F. No. 19-60/92-CZA(299)(Vol. V)(M)/4223

**Sub:- Design for the construction of Aviary for Pheasants and enclosure for Birds of prey at Kanpur Zoological Park, Kanpur.**

### PROPOSED MODERNIZATION OF KANPUR ZOOLOGICAL PARK

Drg Title: PHEASANT AVIARY (LAYOUT PLAN)  
 Date: 11.12.13 Scale: NTS  
 North: Checked By: Vishal

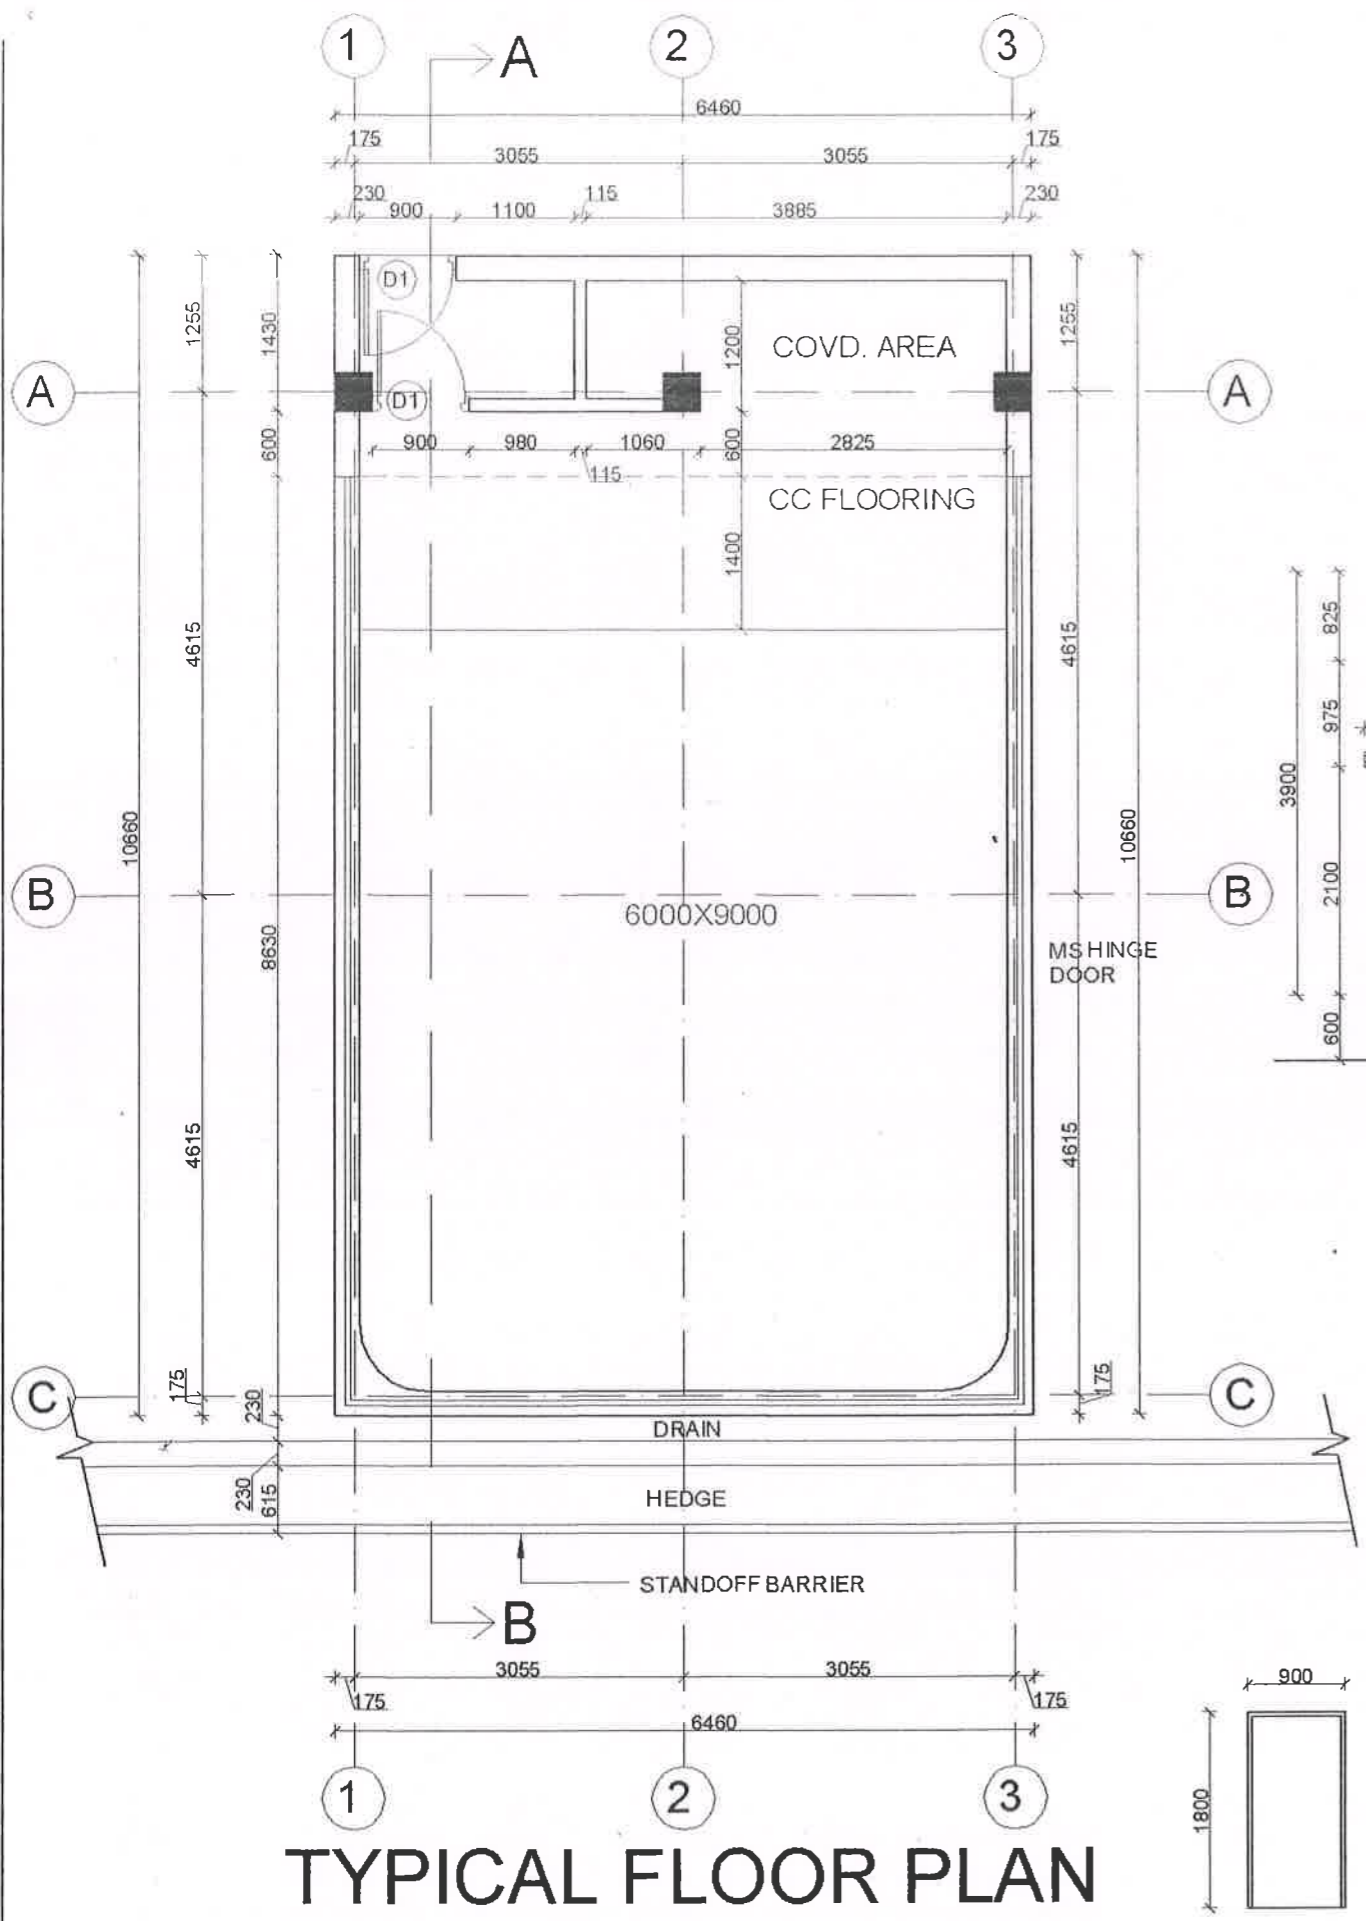
The designs for the Pheasantry was scrutinized and approved subject to the condition that:-

- Space provided for the lawn should have tree growth.
- Screening should be from the main visitors path.
- The aviaries should also have in between screening using the vegetation.
